HISTORIC PRESERVATION COMMISSION

Re: 12 E. Melrose St., Chevy Chase

HAWP #1028583

MONTGOMERY COUNTY HISTORIC PRESERVATION COMMISSION STAFF REPORT

Figure 2: Proposed fencing on-site - 6' fence shown in red, recommended limits outlined in blue.

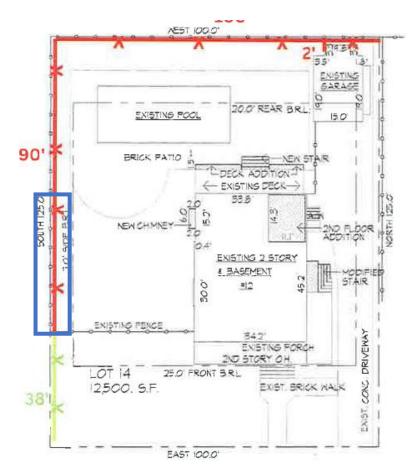
The HPC generally requires fences in the Chevy Chase Historic District that are forward of the rear wall plane to be no taller than 4' (four feet) and have an open picket design to preserve the district's character-defining, open park-like setting. In select instances, the HPC has allowed taller fences where there are needed to satisfy code requirements, but those fences also need to have an open picket character. Staff finds the proposed 6' (six foot) fence along the rear property line will not be visible from the public right of way and is appropriate under lenient scrutiny. Staff does not find all of the proposed solid board fencing along the left property boundary is compatible with the character of the district. While Staff finds a 6' (six foot) tall fence is consistent with the existing fence across the left side yard, the solid appearance does not contribute to the district's open, park-like setting. Several fence designs could be acceptable under the guidance. Staff recommends the HPC include a condition on the approval of this HAWP, requiring the fence along the left property line in front of the historic rear wall plane needs to have an open picket design and be painted. The approximate boundaries of Staff's recommendation are shown in Fig. 2, below). To the rear of the historic rear wall plane, the solid board fence is appropriate.

- 1. The proposed 4' picket fence needs to have a painted finish;
- 2. The fence along the left property boundary, in front of the rear wall plane, needs to have an open picket design and a painted finish;
